Staff Report – Planning & Zoning Item

Date: November 20, 2017
Case No.: Z-17-16
Request: PD MF (apartments) to PD MF (townhomes)
Applicant: Dana Tatum

Z-17-16 Hold a public hearing and consider a zoning change from Planned Development Multiple Family for apartments to Planned Development Multiple Family for townhomes on a 6.285 acre tract of land, located on the northwest side of East Loop 121, just southwest of Holland Road.

Project Title: Front Elevation
Address:

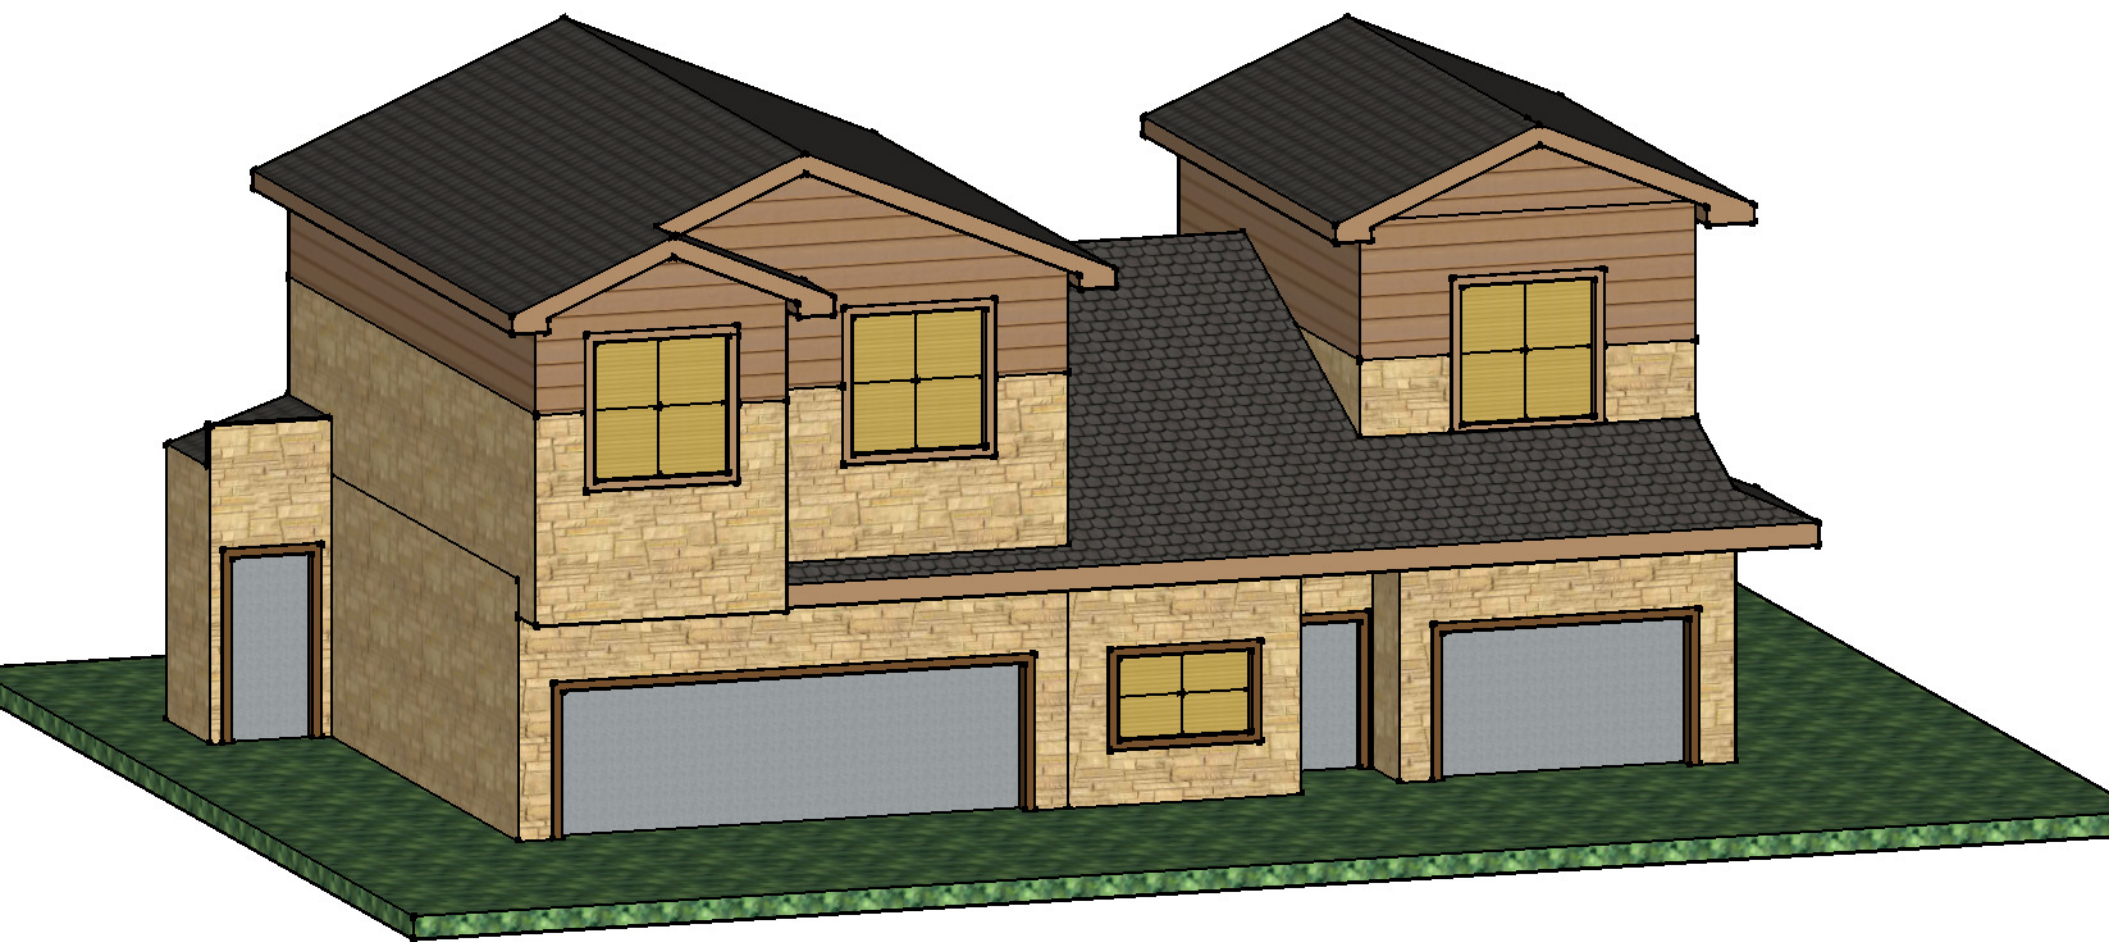
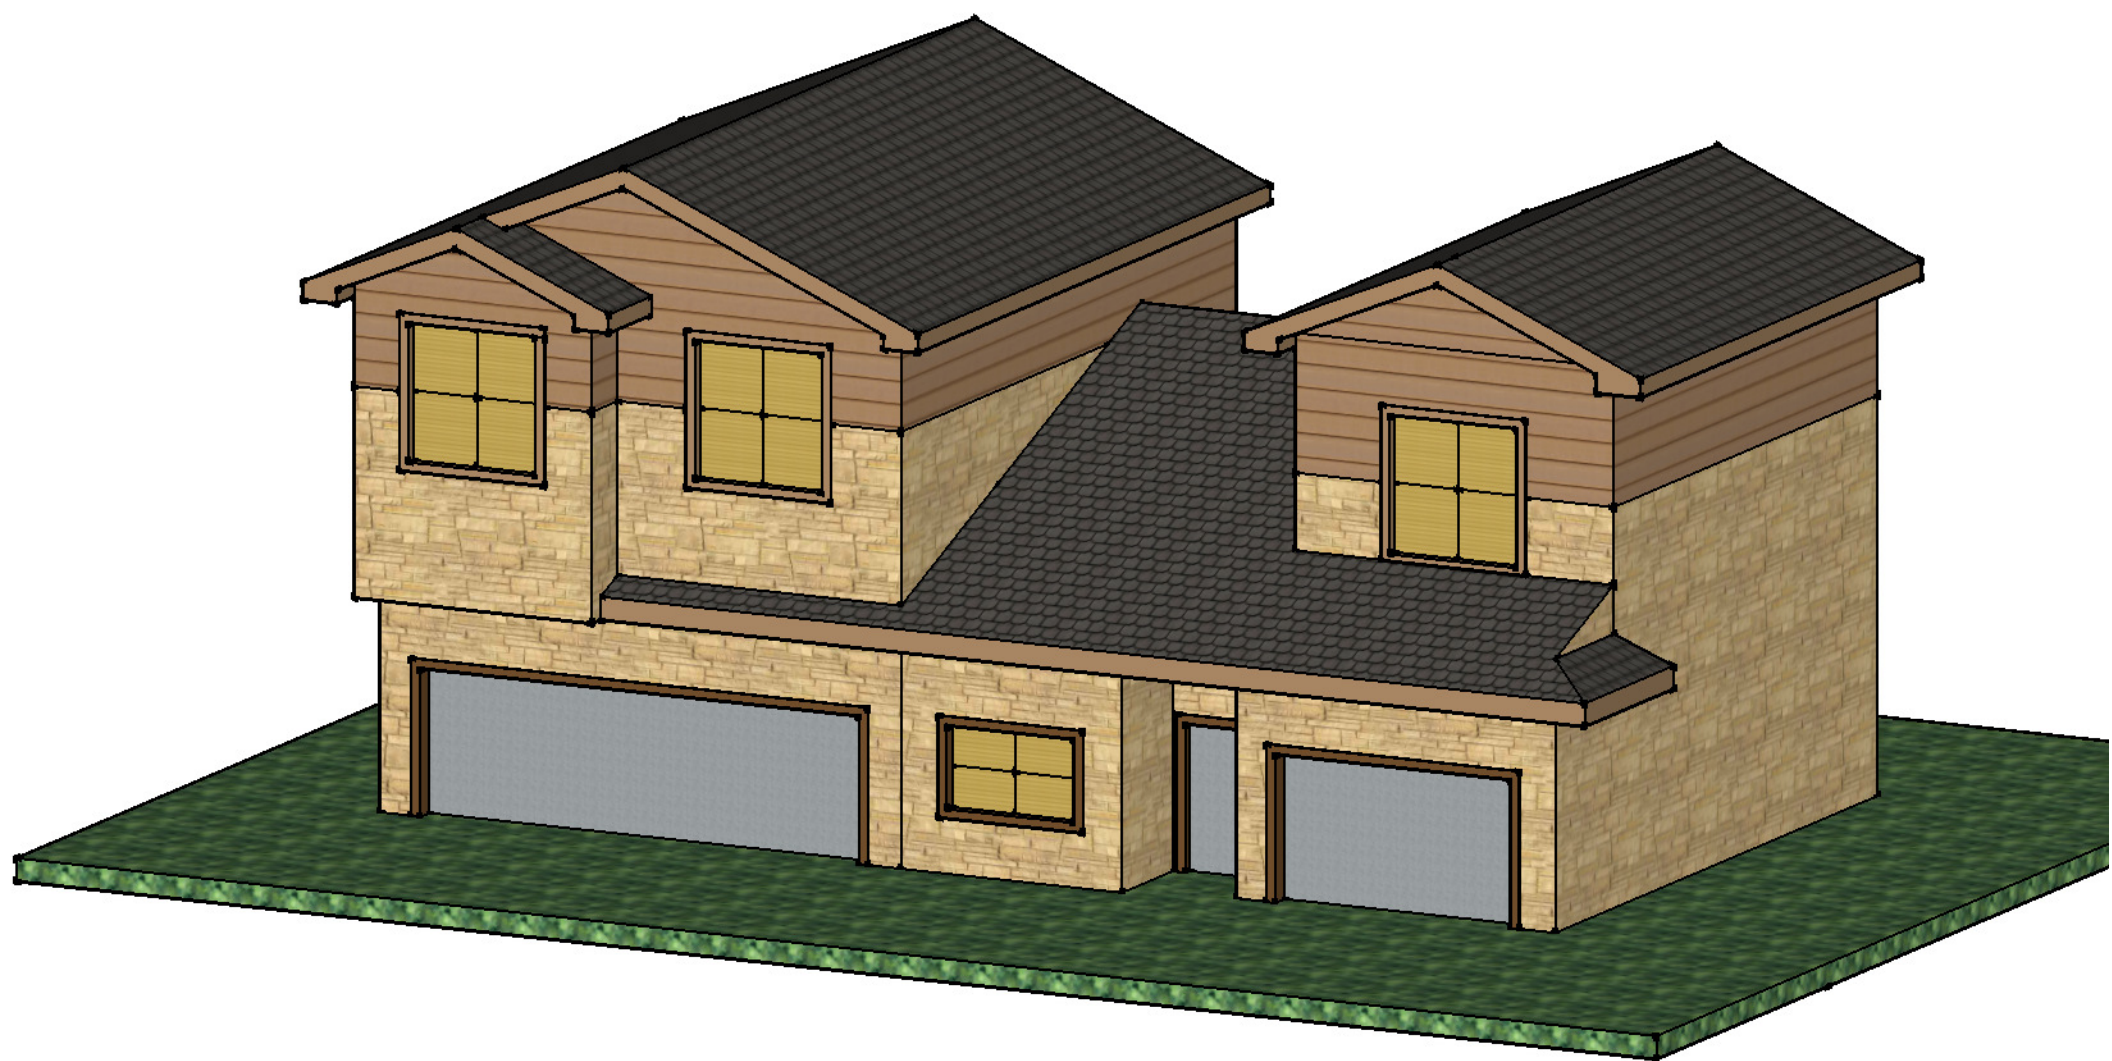
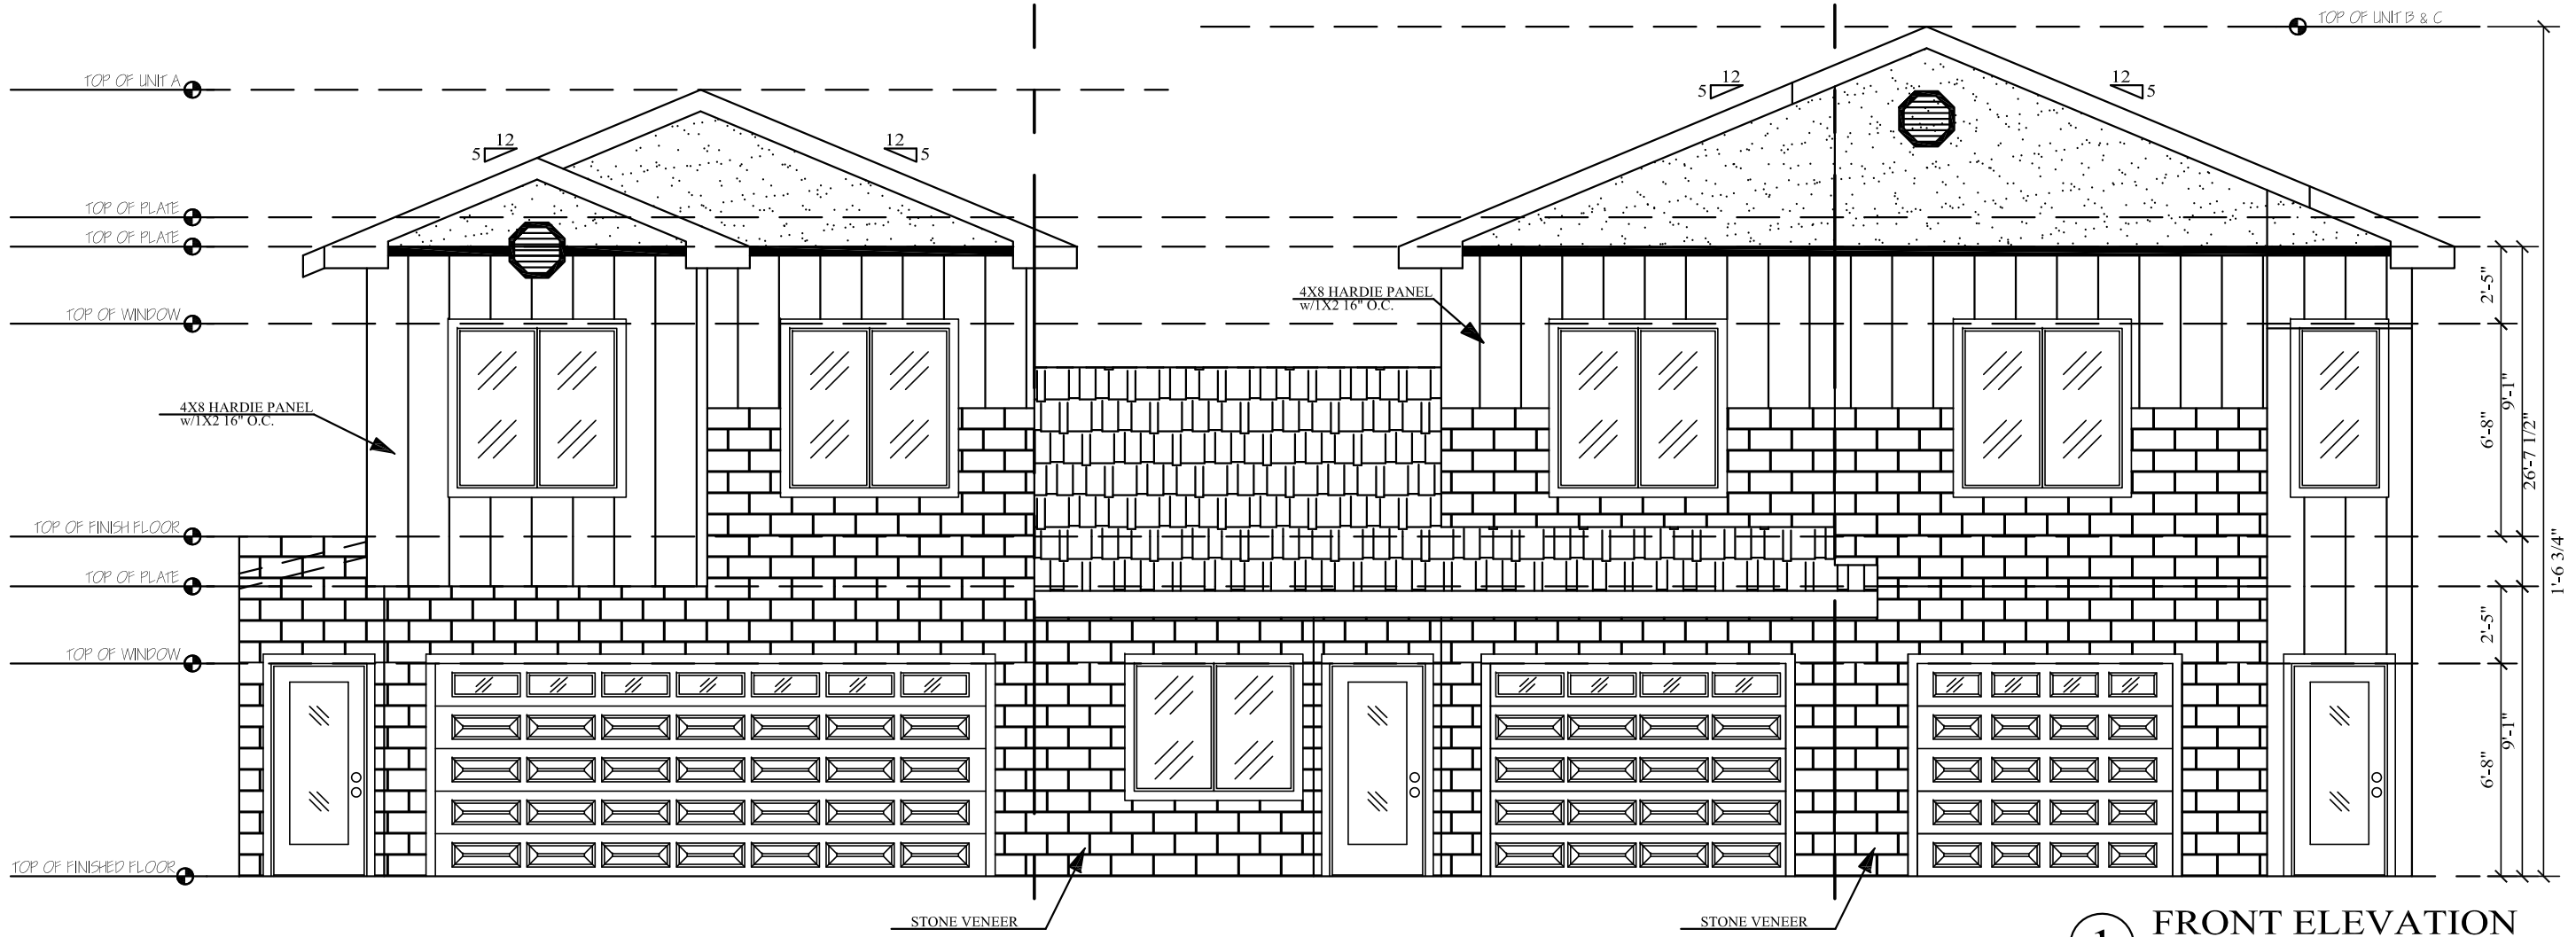
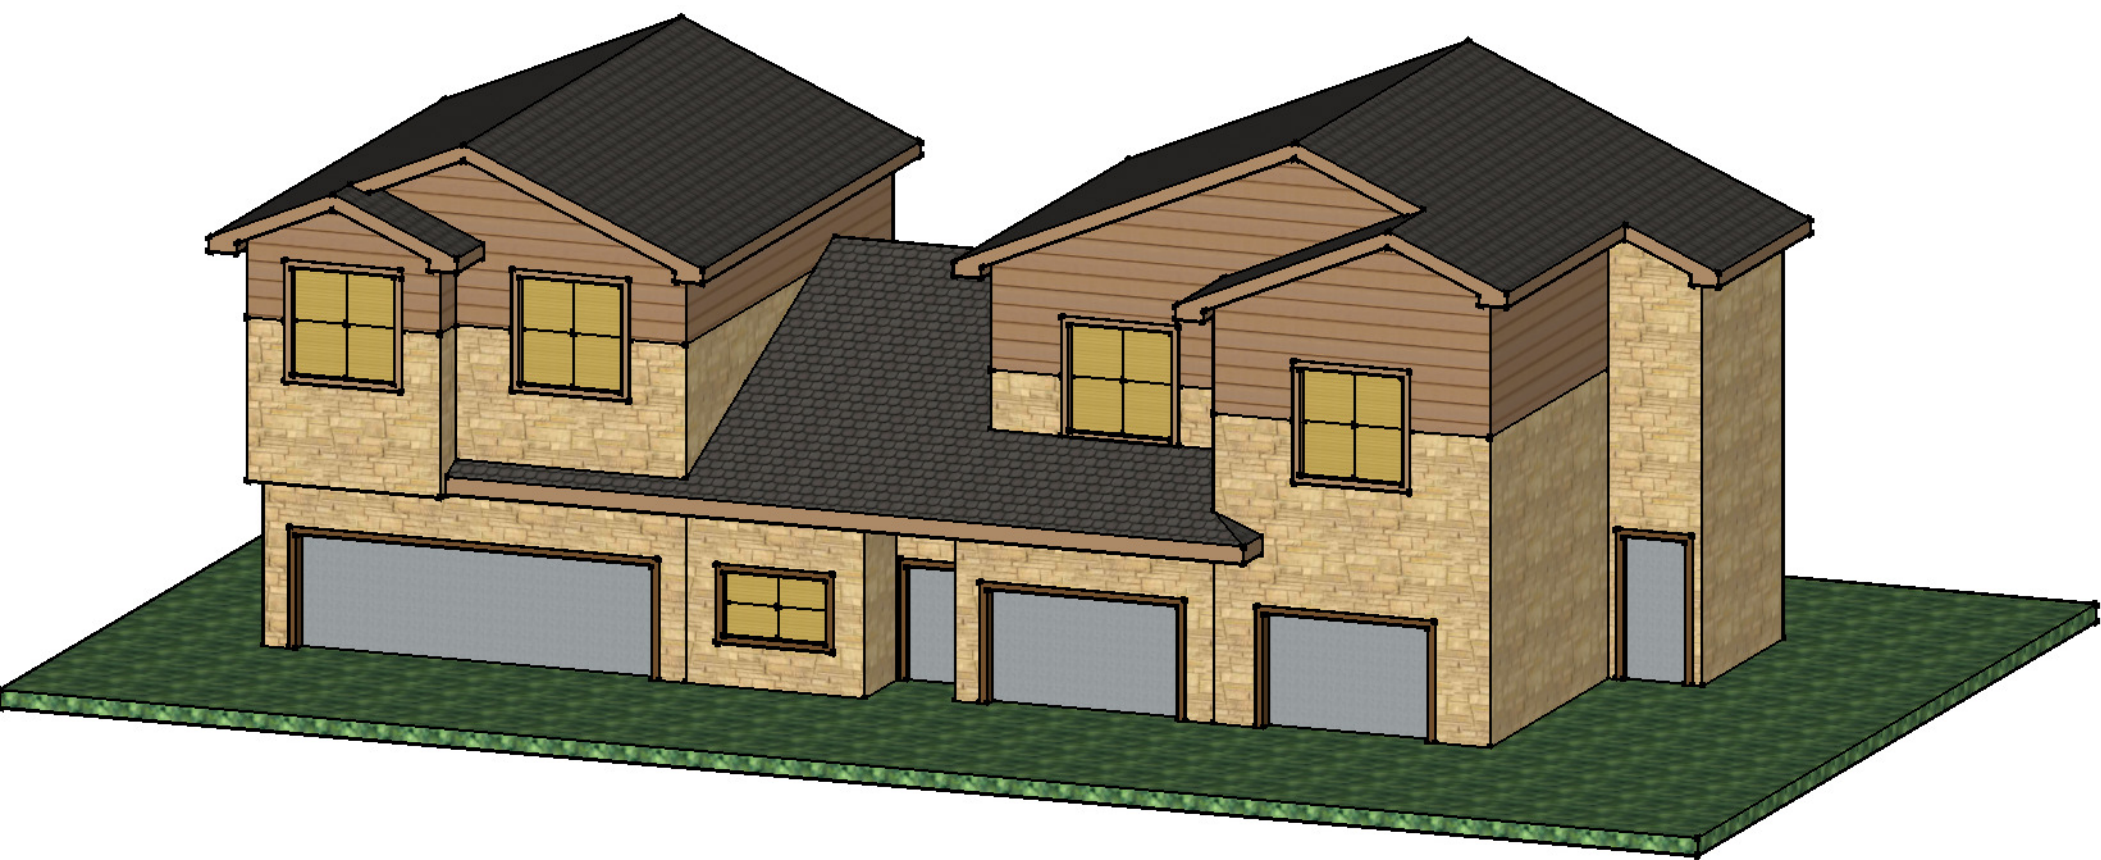
The applicant is proposing to construct a townhome community with 9 cluster modules containing a total of 55 dwelling units. The cluster modules range from 2 units to 12 dwelling units; however, the cluster modules do not exceed 300 feet in length. The Planned Development proposal would allow for a maximum of 12 dwelling units in a cluster module. The lot sizes in this development vary, with the minimum lot size at 25 feet in width and 90 in depth, a total of 2,250 square feet in area. The proposed lots comply with the lot width and depth requirements; however, some lots are smaller than the required lot area of 2,700 square feet. The applicant is requesting the Planned Development proposal allow for some of the lots to be 2,250 square feet in area. Since the applicant is proposing a zoning change to allow for townhomes instead of the previous request for apartments, the overall density is much less than previously approved, an estimate of 113 dwelling units; therefore, these requests appear to be reasonable. All of the dwelling units will consist of 90% masonry, in accordance with the Design Standards.
